PG-FP5 V2.13 Flash Memory Programmer
Release Note

R20UT0689EJ0800
Rev.8.00
Mar 02, 2015

This document describes specifications that have been added or changed, restrictions, and cautions on using the PG-FP5. Also see the user's manual of the PG-FP5 for cautions on using the PG-FP5.

No. 2 Addition of FP5 Manager functions

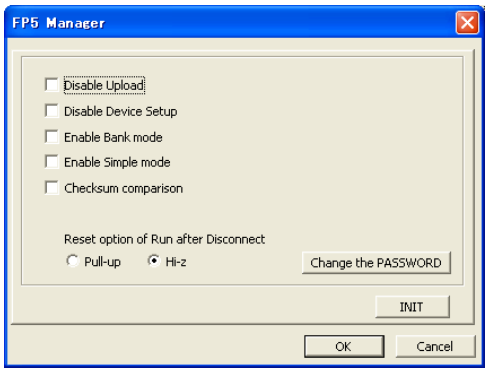
Description: The following FP5 Manager functions have been added.

- Password function
- Upload disable function
- Device setup disable function
- Bank mode enable function
- Simple mode enable function
- Checksum compare function
- Reset pin characteristics switch function

No. 16 Change of layout in **Block protection** area

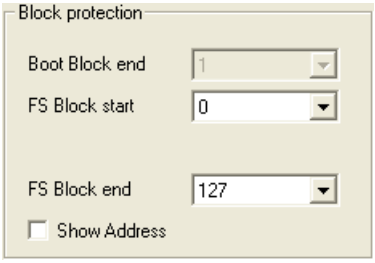
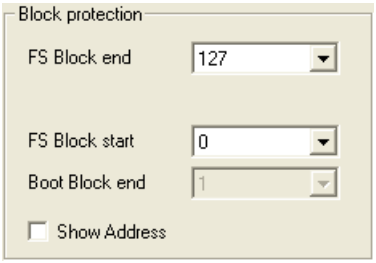
Description: The layout in the **Block protection** area has been changed.

No. 26 Writing to 78K0 microcontrollers by using an external UART clock

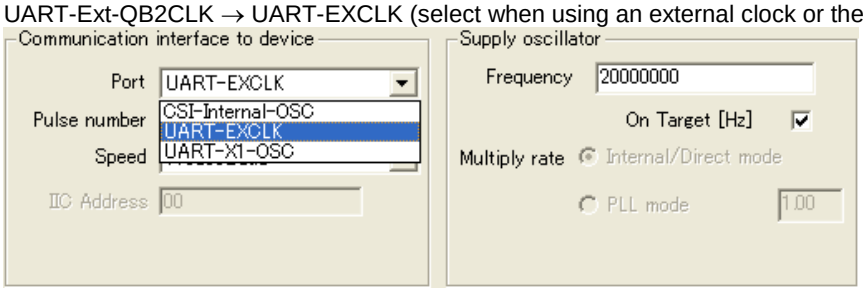
Along with the addition of this feature, the options in the **Port** list box have been changed as follows:

UART-Ext-OSC → UART-X1-OSC (select when using an external resonator clock)

UART-Ext-QB2CLK → UART-EXCLK (select when using an external clock or the FP5 clock)
